**CONTRACT DOCUMENTS
AND
TECHNICAL SPECIFICATIONS
FOR
HVAC UPGRADES
&
INTERIOR RENOVATIONS
&
GREENWOOD LAKE PUBLIC LIBRARY
NYS ED# 44-21-11-02-6-008-005**

LAN Job #4.1361.05
April 1, 2021

END OF ADDENDUM NO. 1

M1.01

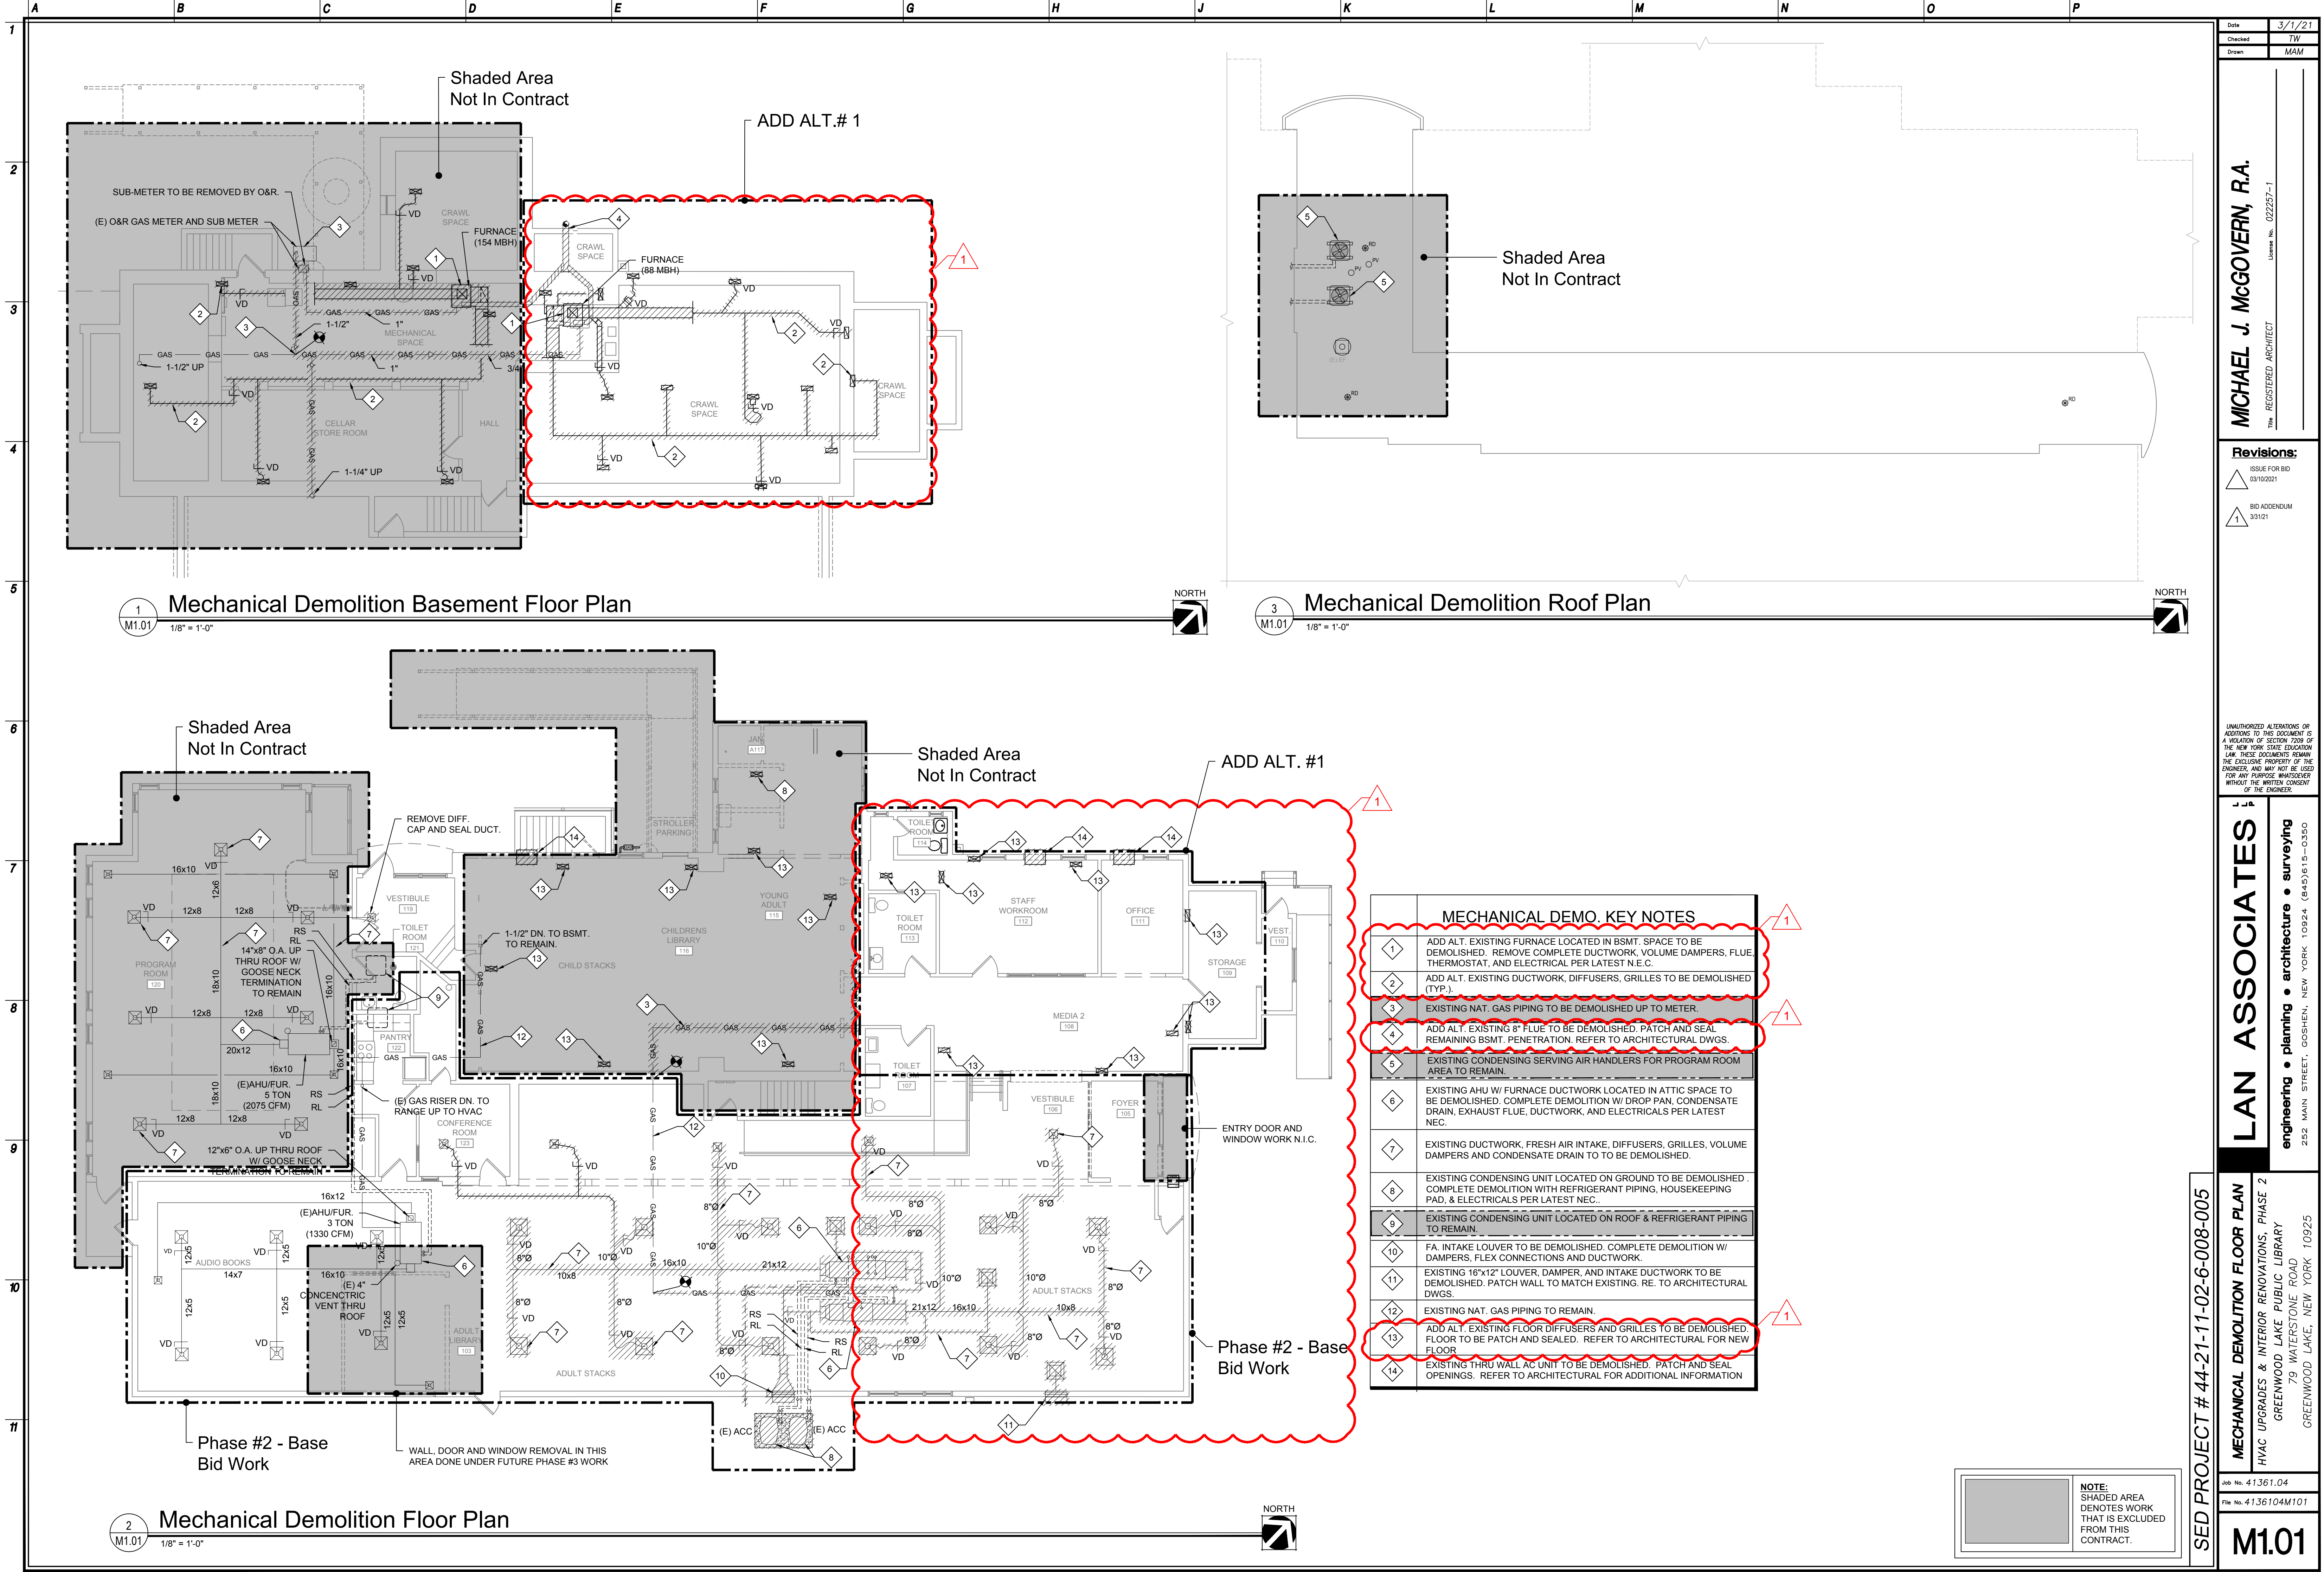
Drawing No.	Addendum Requirements
A2.01	Added a note regarding the scope amendment to exterior entry door D01.
M1.01	Clarification to scope of work included in base bid vs add alternates.
M6.01	Clarification to scope of work included in base bid vs add alternates.

NOTE:
SHADED AREA
DENOTES WORK
THAT IS EXCLUDED
FROM THIS
CONTRACT.
